M-64C MEMORY CARTRIDGE

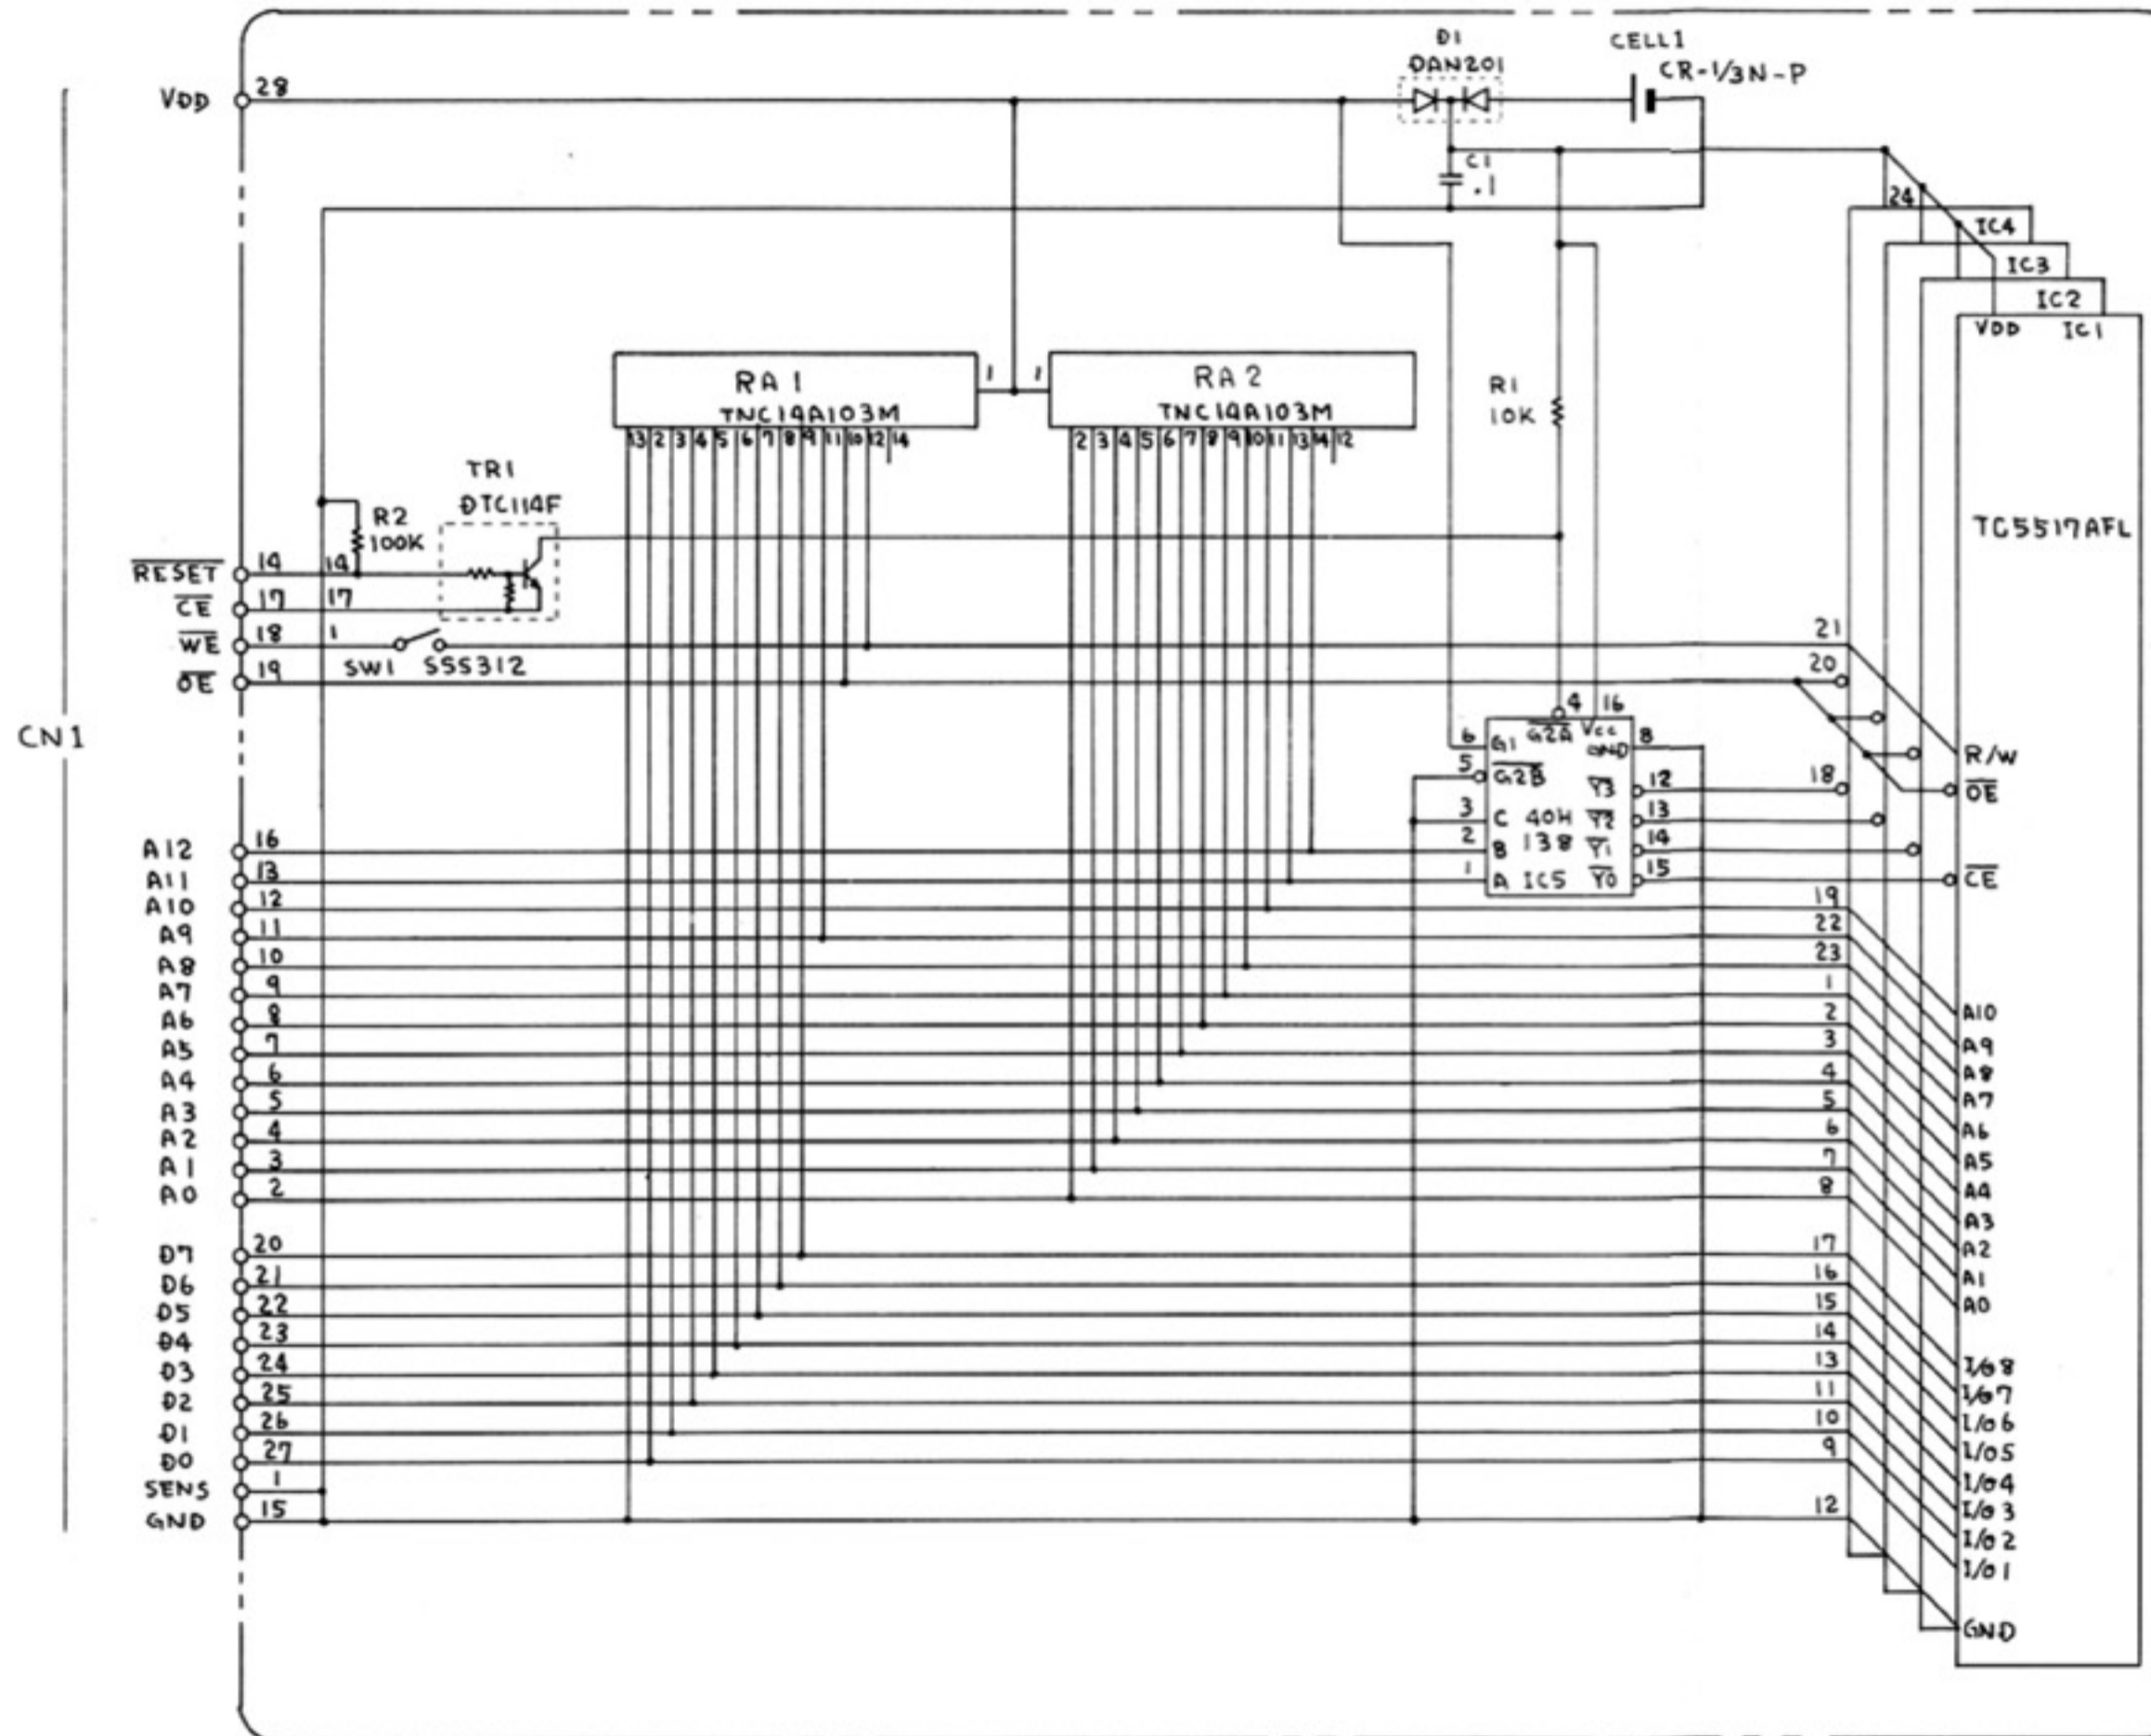
Electrostatic Discharge Protection:
 CHANGE
 R1 10k → R1 3.3k
